SERVICE BULLETIN

Title: 23XL PSIO Installation Instruction
Models Affected:

Number: C9605
Date: 1/25/96
Supersedes:
Date:

To provide a copy of the 23XL PSIO installation instruction sheet number 99TA550150 Rev. A.

APPLIES ONLY TO POWER PANEL LABELS FOR UNITS WITH OIL LEVEL SAFETY SWITCH WIRED TO POWER PANEL TERMINALS 5 & 6 (EARLIER DESIGN) VIA A GRAY-SHEATHED CABLE.

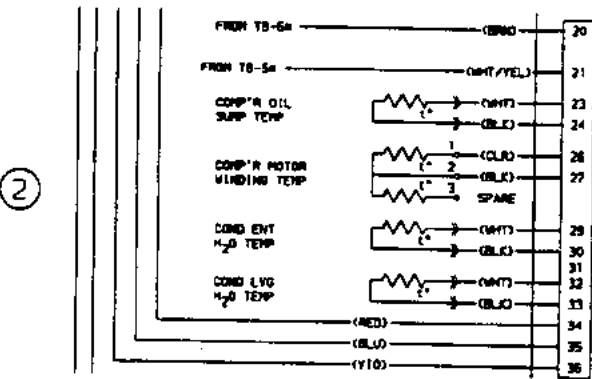
- a. Remove the yellow wire connecting terminal 50 to terminal 6.
 - b. Locate the brown wire connected to terminal 1 and originating from the wire harness leading to the control panel (*not* the brown wire connecting terminal 1 to the oil heater contactor). Relocate that brown wire from terminal 1 to terminal 6.

- c. Affix the provided power panel schematic adhesive label #1 (partial) to the matching location on the original label on the power panel door.
 4. In the control panel:

APPLIES TO CONTROL PANEL LABELS FOR UNITS WITH OIL LEVEL SAFETY SWITCH WIRED TO POWER PANEL TERMINALS 5 & 6 (EARLIER DESIGN) VIA A GRAY-SHEATHED CABLE.

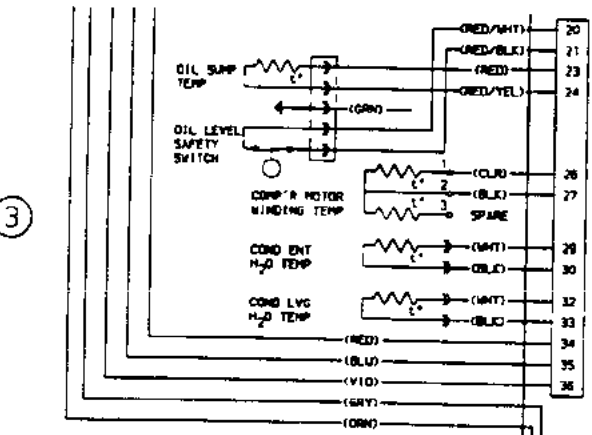
- c. Remove power to the power panel.
 - d. Install the new PSIO module (with Version 14 or later software).
 - e. Locate the white/yellow wire connected to plug J7, pin #19. Move this wire from pin #19 to pin #21 (within plug J7).

- f. Reconnect all plugs from the PSIO module.
 - g. Affix the provided control panel schematic adhesive label #2 (partial) to the matching location on the original label on the control panel door
